# Service description

Product: SP200	Service description no: 3112-S014	Ver: 1
-------------------	---	-----------

Gearbox change 90°.

Figure 1

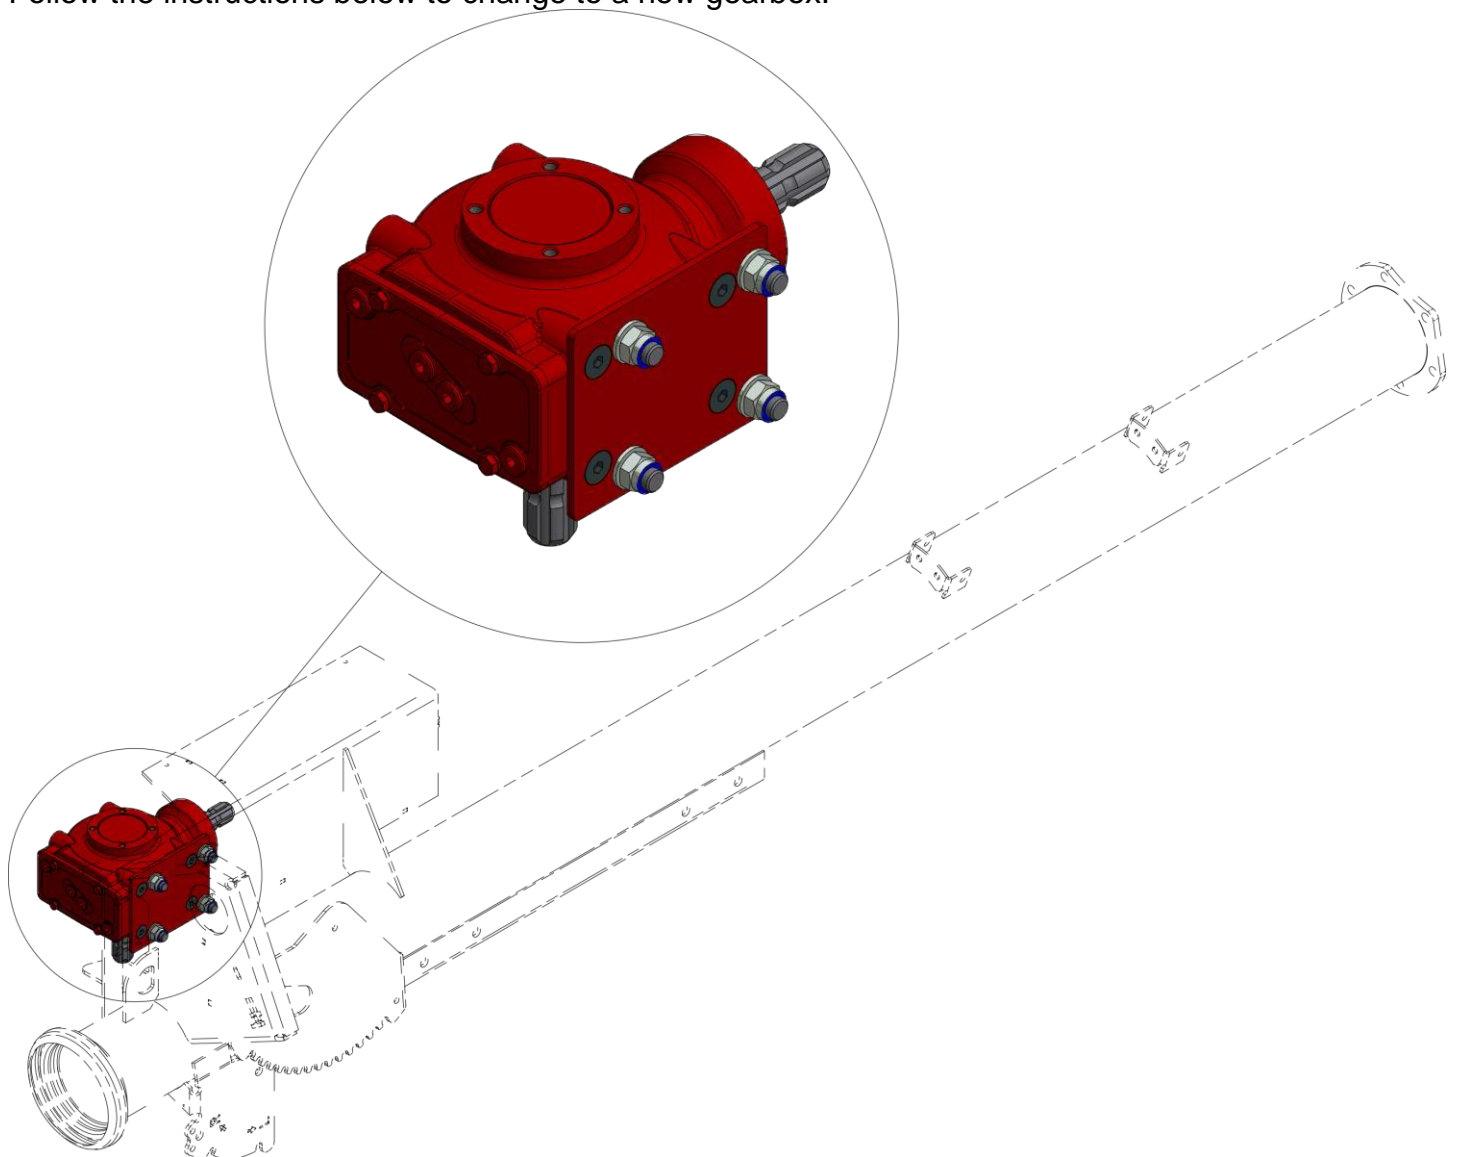
The hole pattern of new a gearbox does not match the hole pattern on a pump stem.

Follow the instructions below to change to a new gearbox.
